Environmental Review Team Report

Stonehedge

Granby, Connecticut

Environmental Review Team
Report
on

Preliminary Subdivision Plan

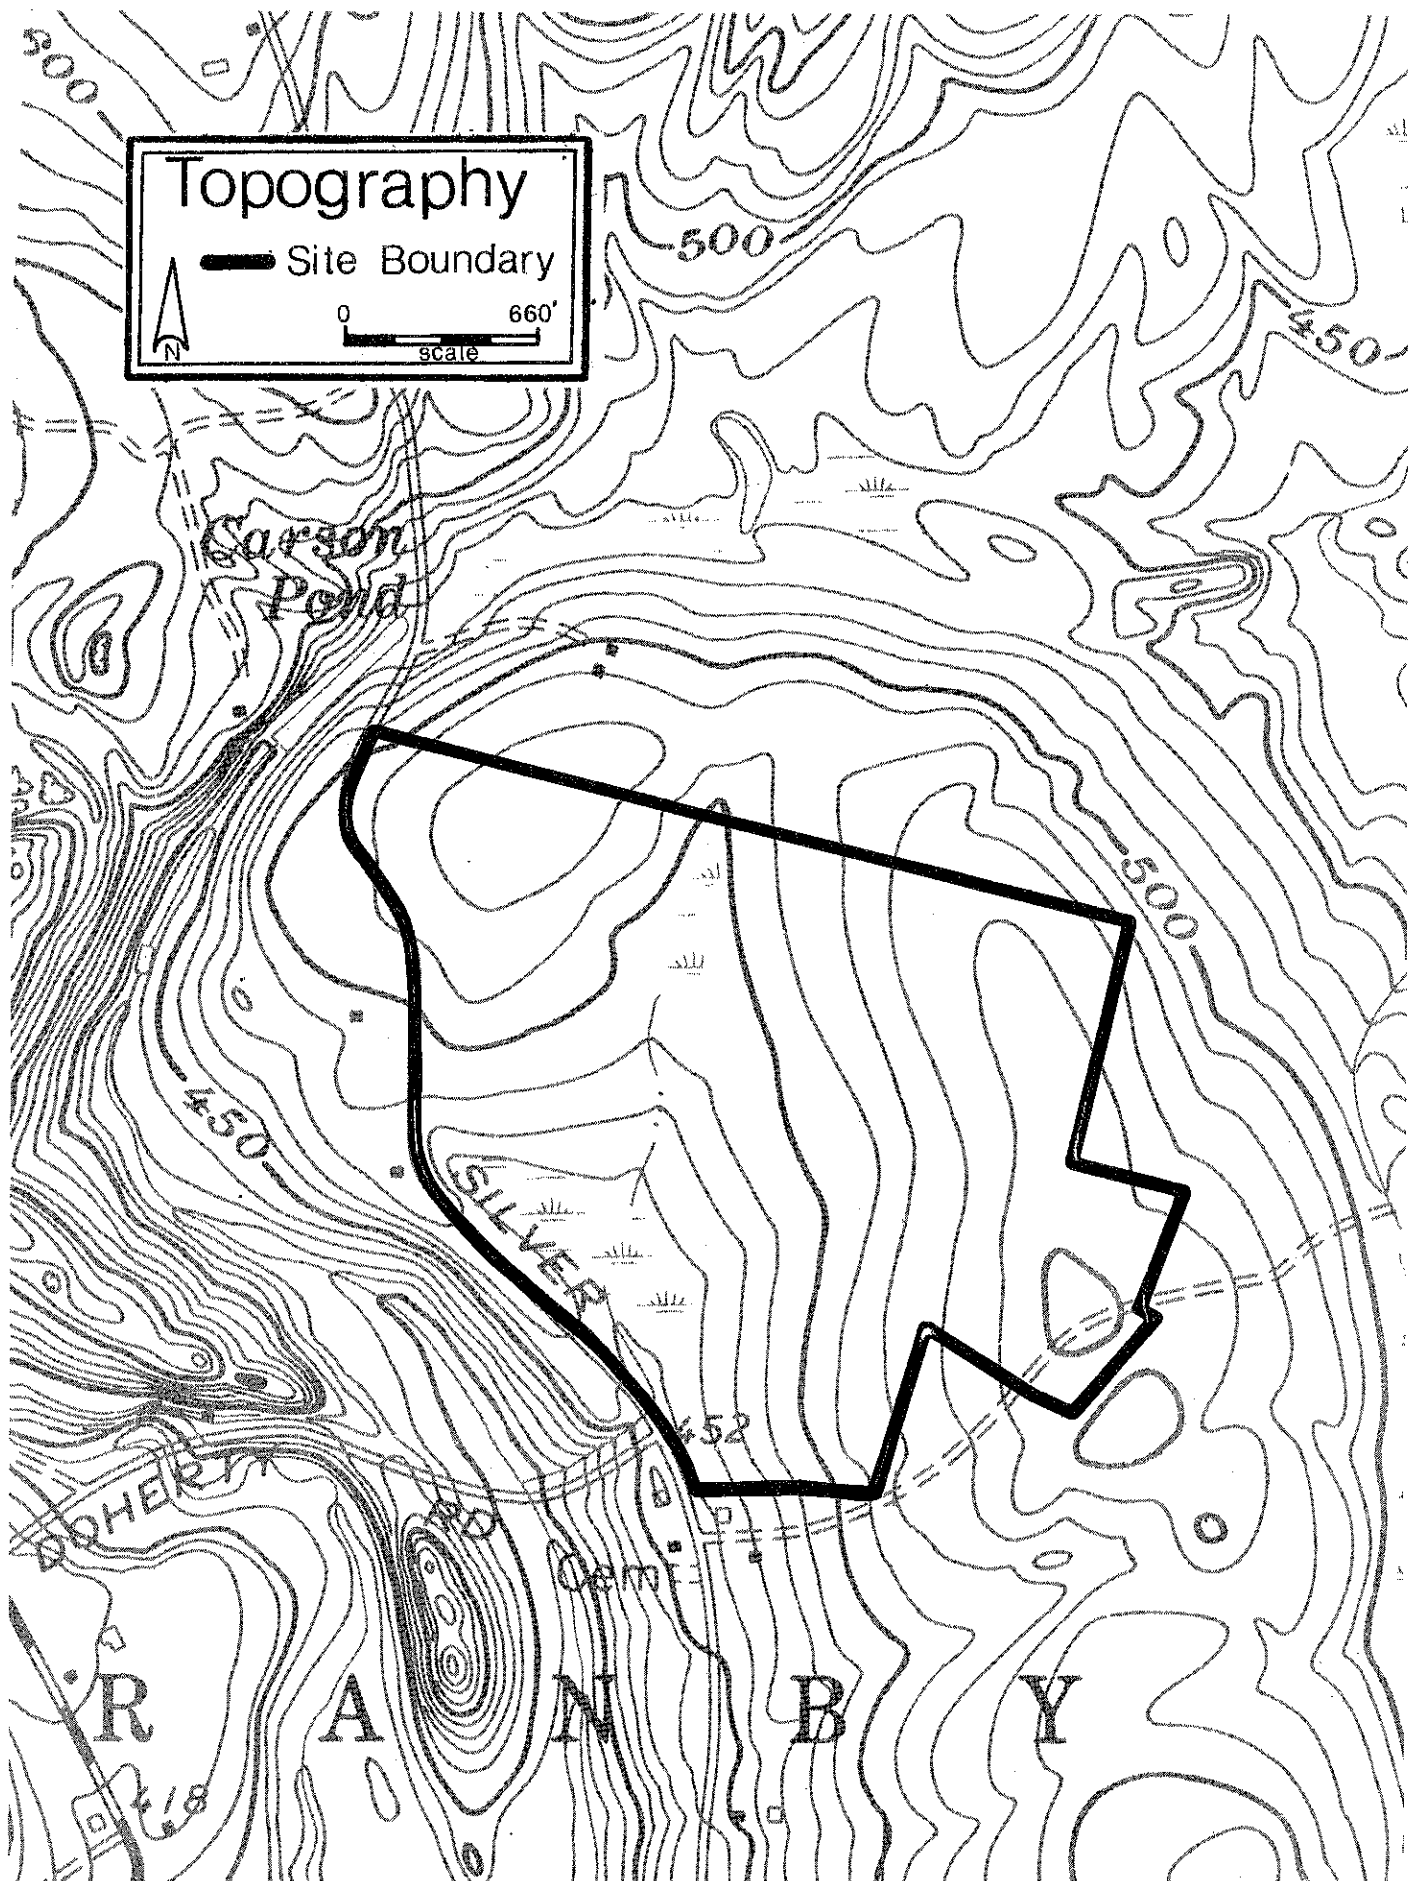
A sanitarian from the State Department of Health served as Team Sanitarian for this project. As only one deep test pit was provided per lot, the sanitarian feels that additional testing would be necessary to properly locate septic system reserve areas. Both acceptable location of the septic system and its reserve area, in relation to the location of the actual building site, should be shown on the final plans to indicate lot suitability for establishing these facilities.

The planned road will cross a stream and high water table area near lot #5 and #33. This area is critical because sediment here will have direct access to the stream. The culvert and fill placed here for a road should be immediately stabilized. Riprap can be used around the culvert. Side slopes should be well vegetated.

The wetland along Silver Street and the wet area by lot #5 should be considered as stormwater retention areas. It is possible that they presently have the capacity to store increases in storm water runoff due to the development. Small, more frequent storms should be considered in the design.

**WATERSHED
AREAS**

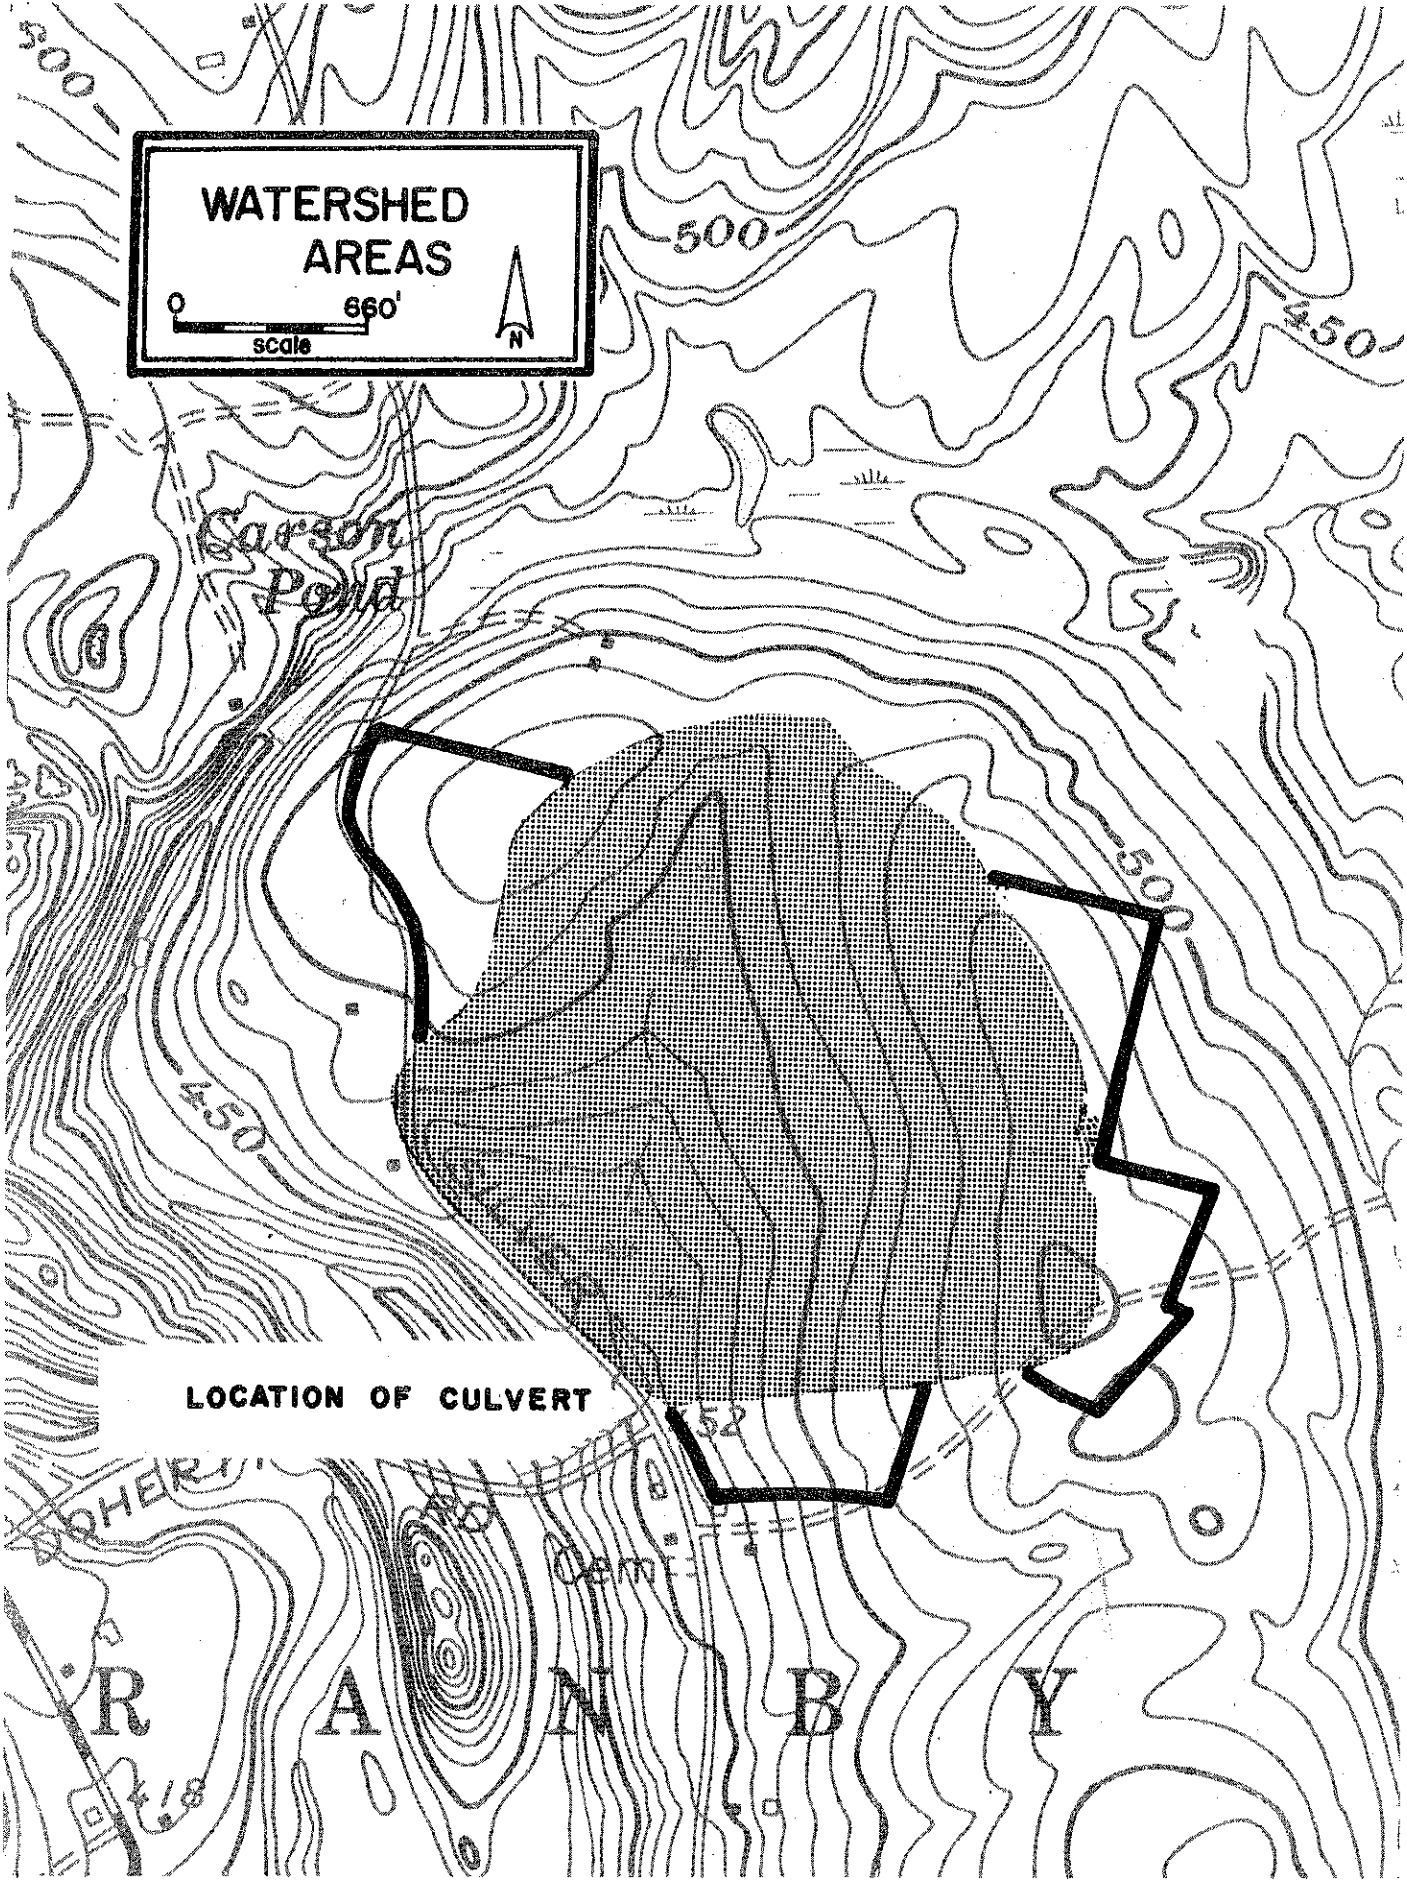
Most runoff from the site flows to a swampy area near Silver Street and from there is channeled westward through a culvert toward a tributary of Salmon Brook. The drainage area for the culvert is shown in an accompanying illustration. Development of the site as planned would increase the volume of runoff shed from the site for storms of given magnitudes. These increases, in turn, would add to peak flows at the culvert and in downstream areas, unless runoff retention structures were utilized.

Estimated present and future peak flows at the culvert, based on a hydrologic analysis procedure outlined in Technical Release No. 55 of the Soil Conservation Service, are listed in the accompanying table. Peak flows are given for storms having average periods of recurrence of 2 years, 10 years, 25 years, 50 years, and 100 years. Each storm would have a duration of 24 hours. All flows are given in cubic feet per second.

As the table indicates, percentage increases in peak flows are greatest for frequent, relatively low-intensity storms, but increases for the less frequent storms are still large. Consideration should be given to methods of temporary runoff retention that would prevent or at least reduce these increases. It is not known whether the present culvert on Silver Street is large enough to pass the post-development flood flows. If so, erosion and flooding problems that might be associated with the peak flow increases could be passed downstream. In this circumstance, the existing culvert under Doherty Road at the Salmon Brook tributary might also warrant examination. If the Silver Street culvert would restrict the bolstered peak flows, it should be determined whether the result would be flooding of Silver Street near the Doherty Road intersection or merely temporary ponding

near the mouth of the site's major wetland. If the wetland can be used for natural runoff retention without inducing road flooding, it might even be possible to reduce the size of the culvert on Silver Street to restrict the potential flow rates. Fortunately, since the drainage area of the culvert is almost completely contained within the site, future development of nearby areas would not affect the culvert unless piped or rerouted drainage from such areas were allowed to be discharged on the site.

A possible alternative method of partial runoff control would be to establish a retention basin in the small wetland on lot 5, just north of the proposed road location. However, this alternative would interfere with the full use of the lot and could also be attractive to breeding insects. On the other hand, such a basin would reduce potential erosion problems in the swale south of the proposed road.

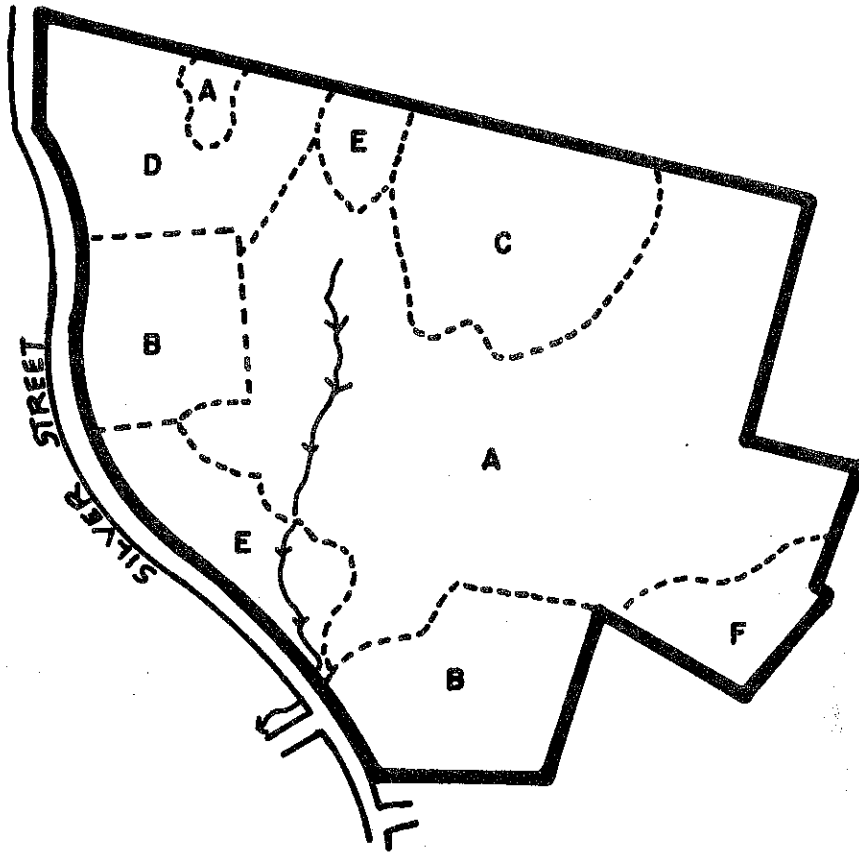
The 100± acre tract proposed for development into the Silver Street Corporation Subdivision may be divided into six vegetation types (see vegetation type map and vegetation stand descriptions). Hemlock and white pine make up 47 acres, mixed hardwoods 28-acres, open fields 16-acres and wetland 9-acres. Preservation of the healthy vegetation and thoughtful placement of houses on lots will help to retain the rural atmosphere in this area.

The trees in Stand D (mixed hardwoods) are becoming crowded; this condition is starting to cause a decline in tree health and vigor. A thinning in this stand, producing fuelwood as a product, will reduce competition between residual trees for space, light, water, and nutrients. Over time the trees remaining in this stand should respond by becoming healthier and more stable. Ideally this thinning should remove approximately one-third of the total volume. It should be focused on removing poor-quality trees, damaged trees, unhealthy trees, undesirable species such as red maple, and those trees that are directly competing with high-quality, desirable trees. Large, healthy, high-quality trees should be left in the residual stand.

Stand F (mixed hardwoods) is at this time overcrowded with poor-quality gray birch which are overtopping an understory of white pine. Eventually the gray birch will die and the longer lived white pine and red oak will become the main constituents of this stand. The condition of this stand could be improved by removing gray birch, which are competing with the white pine and scattered red oak. The white pine in this stand are young enough to respond positively to being released.

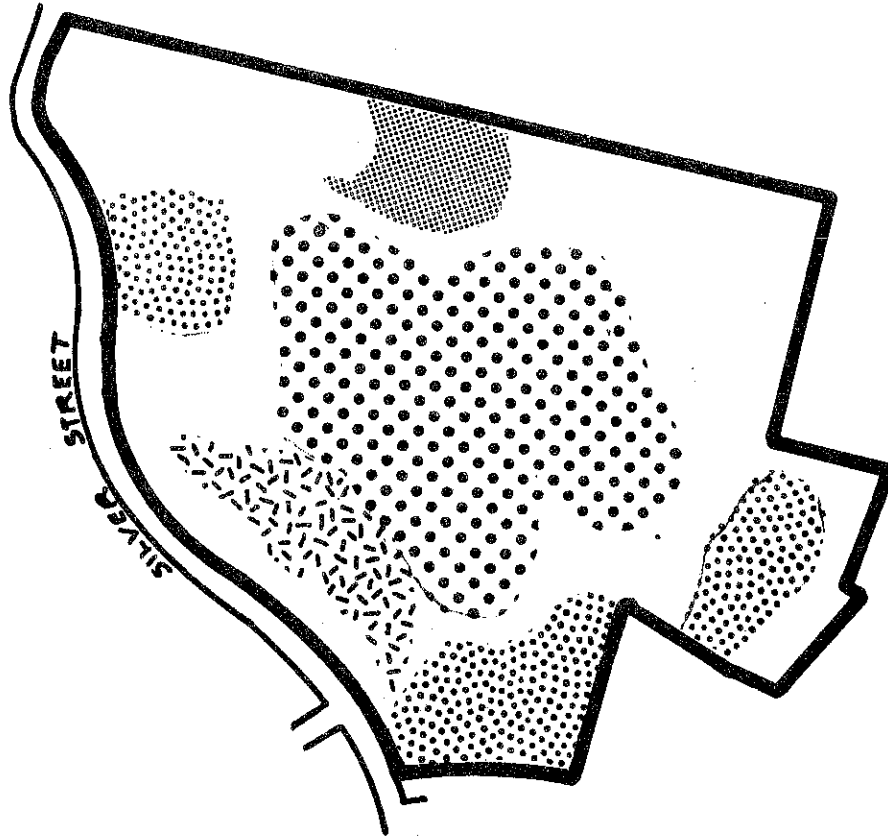
The valuable wildlife areas map points out sections of the property which should be avoided by substantial development impact if at all possible. Open fields or fields reverting to forest are high-use areas and good sources of food. Dense hemlock stands provide cover from severe winter conditions for deer. White oak provides a valuable food source. Wetlands in the Conservation Easement provide good sources for water and food.
